Technical Memorandum

SUBJECT: Review of the Robertson County Water Supply Corporation Simsboro Well Aquifer Evaluation Report

DATE: April 5, 2023

Figure 2. Analytical Simulated Drawdown Effects After Proposed Robertson County WSC Well Pumping of 529 ac-ft/yr for 1-Year

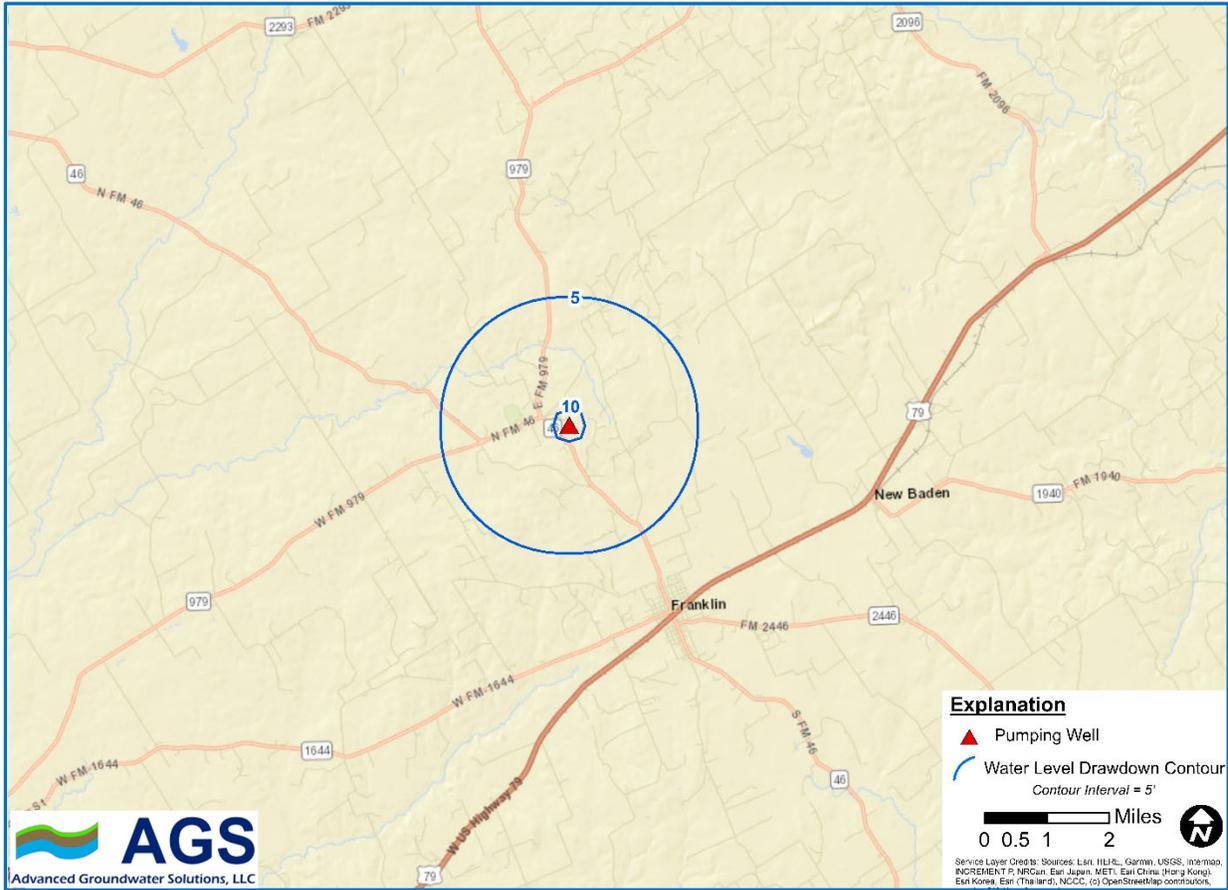
Figures 2 and 3 show the estimated AGS analytical modeling drawdown contours that result from pumping 529 ac-ft/yr for 1-year and 10-years, respectively. Simulated drawdown values in wells screening the Simsboro Aquifer within 1 to 5 miles of the proposed well are estimated to be less than 10 feet after pumping the proposed well at 529 ac-ft/yr for 1 year and 10 years.

Figure 4. Projected GMA 12 2021 Planning Cycle DFC Water Level Decline at the Proposed Robertson County WSC Well

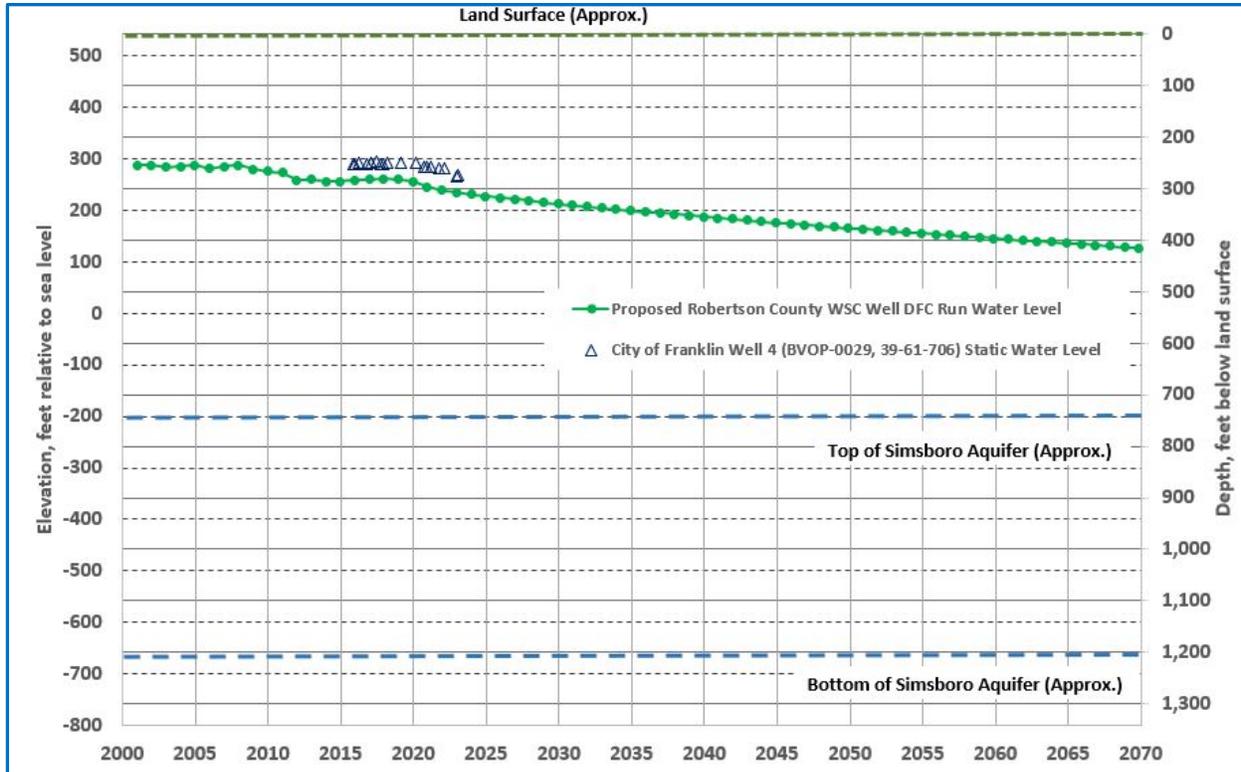
The graph illustrates the relationship between the land surface, estimated static water level through time, and the estimated top and bottom of the Simsboro Aquifer at the location of the proposed RCWSC well. Historical static water level measurements are also shown on Figure 4 for the City of Franklin Well 4 (BVOP-0029, State Well Number 39-61-706), which is located about 3 miles to the south-southeast of the proposed RCWSC well and screen sands of the Simsboro Aquifer in the depth interval of about 1,093 to 1,214 feet below land surface or approximately -644 to -765 feet rsl.

Available drawdown in wells in the Simsboro Aquifer will decline over time based on the DFC simulation. Although not evaluated or discussed in detail herein, these levels of water level decline in wells and artesian head decline in the aquifer will have some impact on vertical leakage, intercepted discharge, reduction in confined and unconfined storage, and potential flow directions in the aquifer.

Figure 6 - Theis - Simulated Drawdown After 1 Year

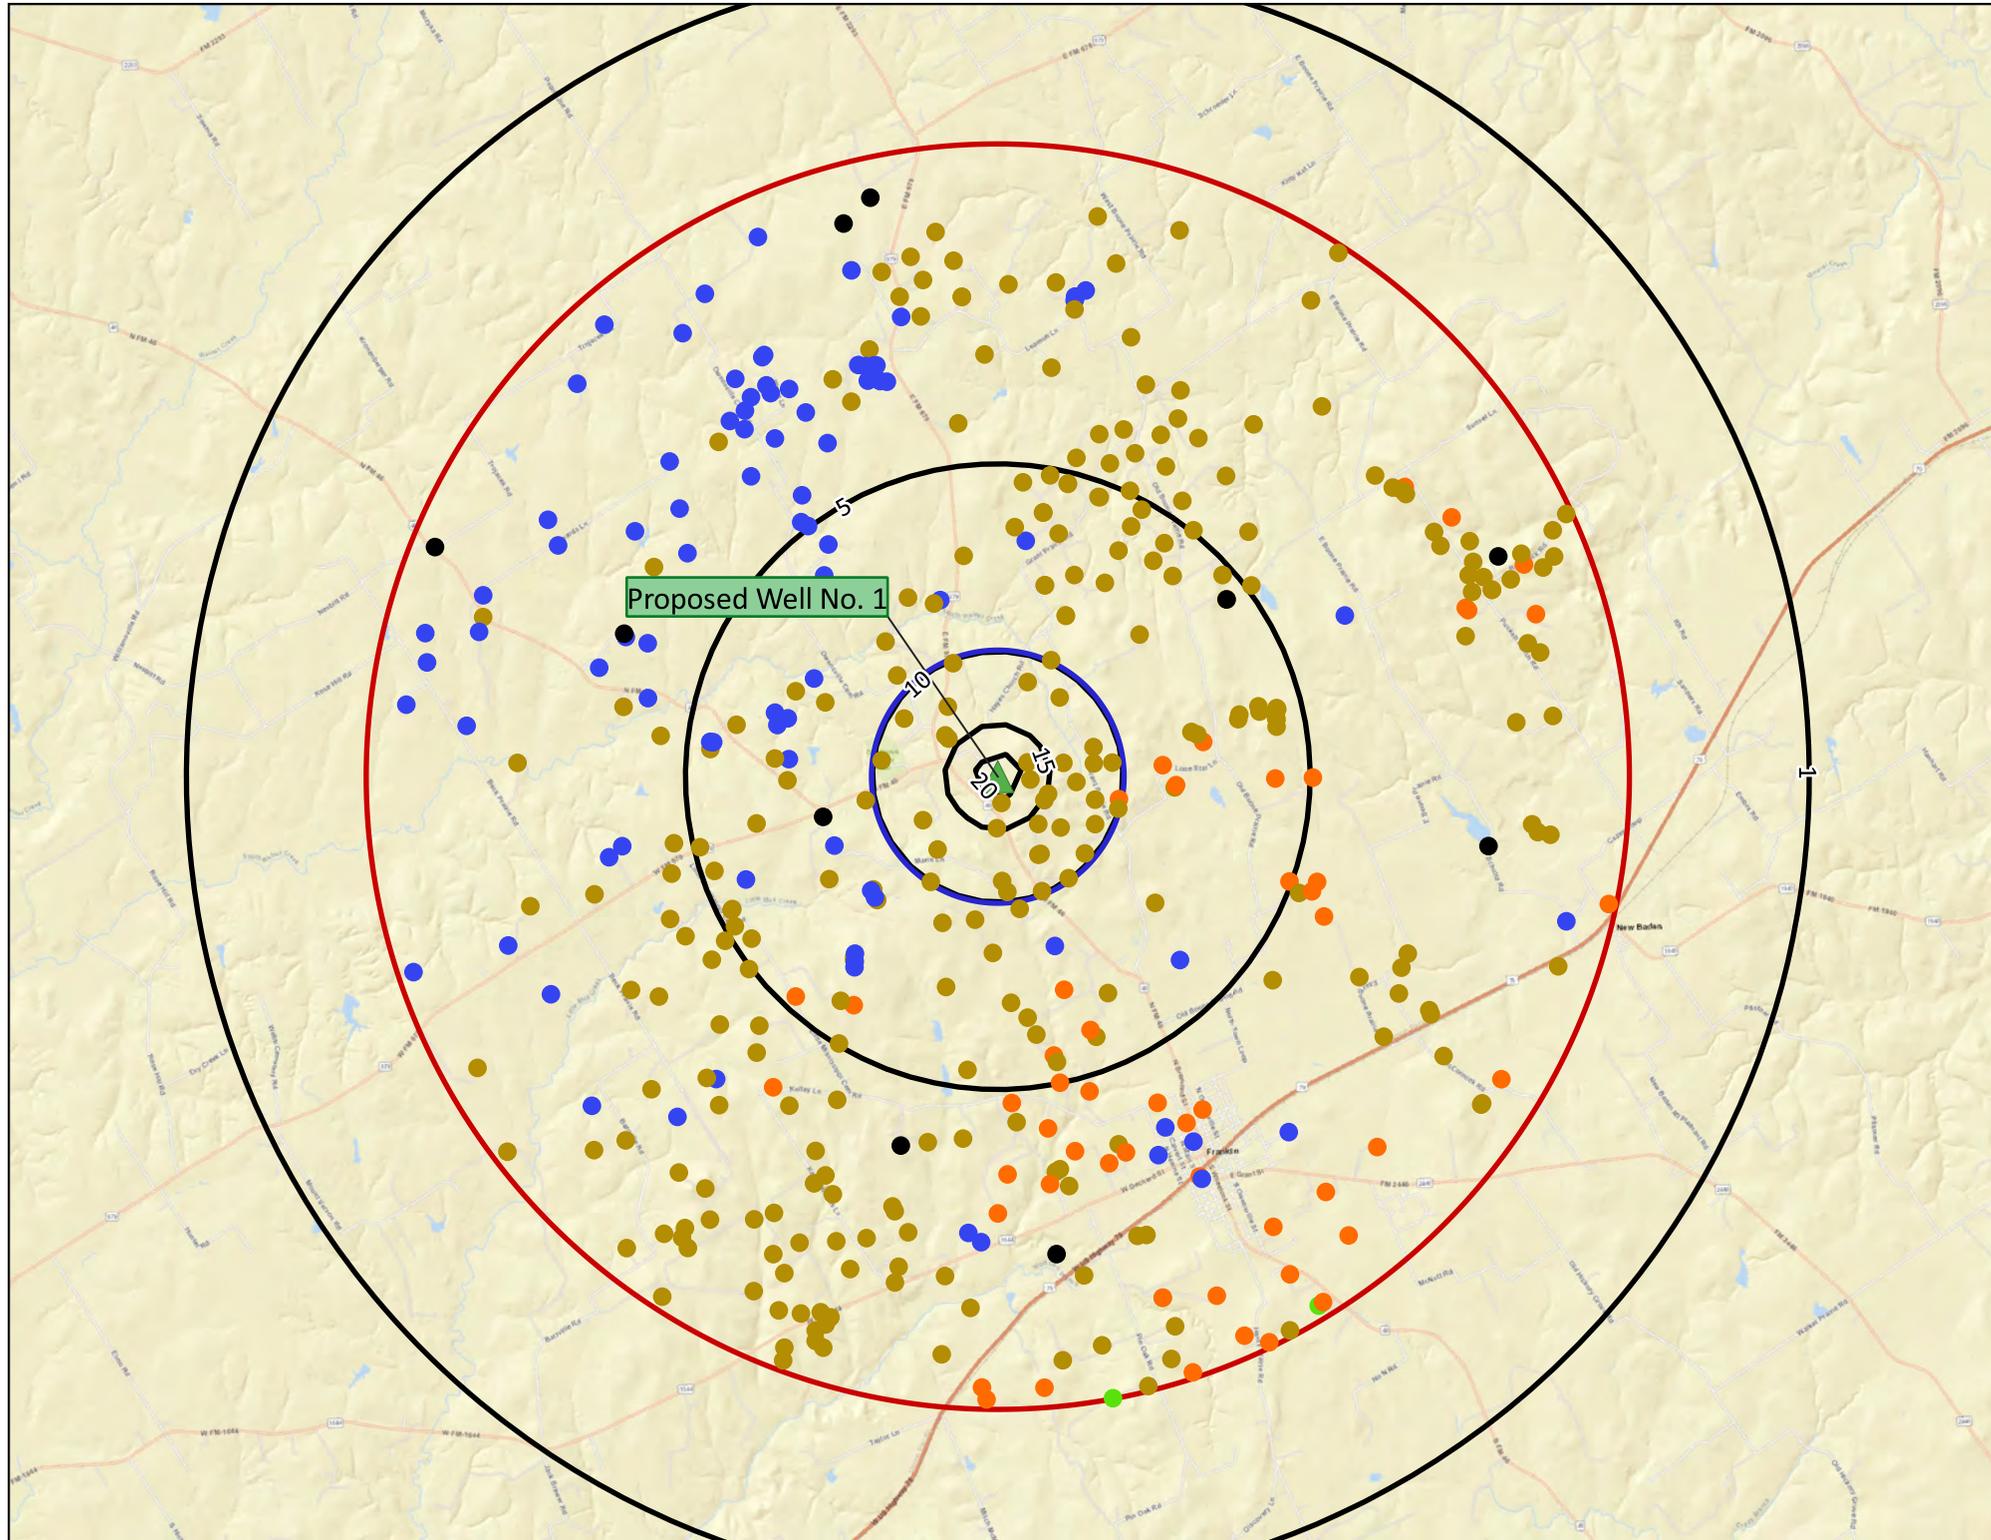
TGI used an analytical model based on the Theis non-equilibrium equation to estimate theoretical potentiometric head declines at and surrounding the proposed well. A transmissivity value of 40,000 gallons per day per foot (gpd/ft) and storage coefficient of 0.005 were simulated at the proposed well location to estimate drawdown after 1 and 10 years of pumping. A copy of the TGI 1-year and 10-year analytical simulated interference drawdown illustrations from the AER (TGI

Figures 6 and 7) are attached to this memorandum. TGI did not reference the well pumping rate used in the analytical modeling simulations and AGS was unable to replicate the TGI simulation results based on the information provided in the AER.

The TGI AER did not include the pumping rate used in the AER analytical simulations. AGS could not replicate the model simulations with the information included in the TGI AER and performed analytical model simulations based on a pumping allocation of 529 ac-ft/yr for 1 year and 10 years. The TGI analytical modeling simulations appear to overestimate the pumping effects from the proposed RCWSC well.

AGS performed analytical simulations using a Theis analytical model with a production rate derived from the requested allocation of 529 ac-ft/ year (328 gpm), a transmissivity of 40,000 gpd/ft and storage value of 0.0002 from the Central Portion of the Sparta, Queen City and Carrizo-Wilcox Aquifers GAM. The AGS simulations estimate less drawdown for the proposed well than shown in the TGI AER. TGI estimates that 59 feet of drawdown would occur at the proposed well after 1 year of pumping and 66 feet of drawdown after 10 years of pumping. The AGS simulations estimate about 22 of drawdown (at 1-foot from the proposed well) would result after pumping the proposed well for 1-year at a continuous pumping rate of 328 gpm and about 25 feet of drawdown (at 1-foot from the proposed well) would result after pumping the proposed well for 10-years at a continuous pumping rate of 328 gpm.
